CERTIFICATE OF APPROPRIATENESS

Application Number: HDC2025-00093

Project Address: 9851 Hamilton

Construct parking lot and trash enclosure per submitted application materials.

SHEET NUMBER
D-1.0

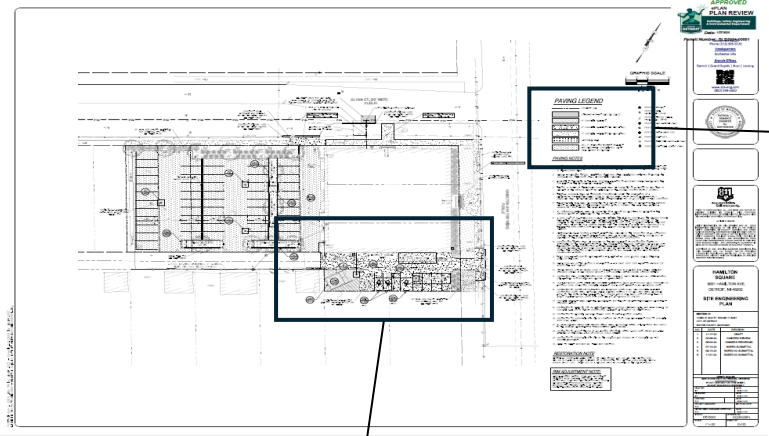
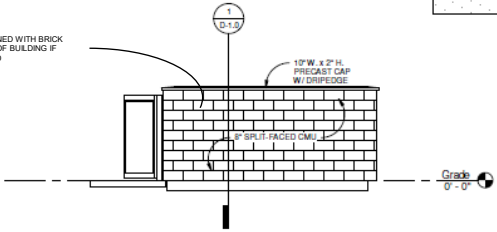
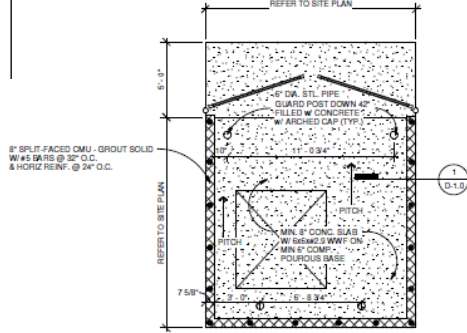
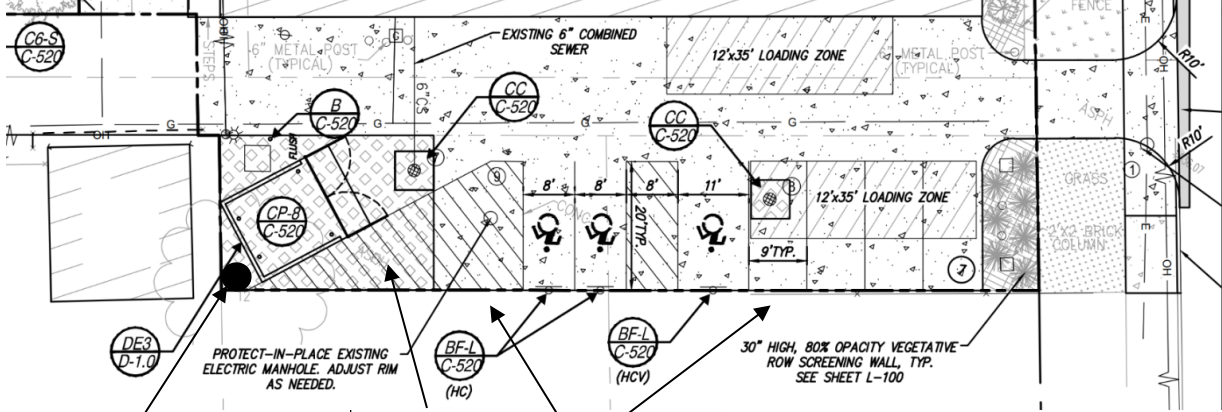
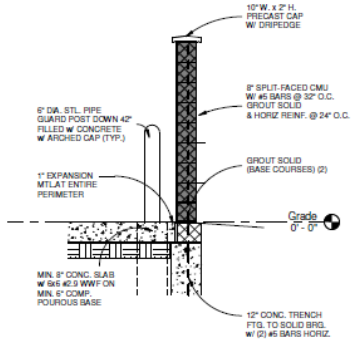
- Brick cladding compatible with the building is used on the trash enclosure, which will be submitted for review by HDC staff, and the large shade tree shall be removed at the southwest corner of the lot.
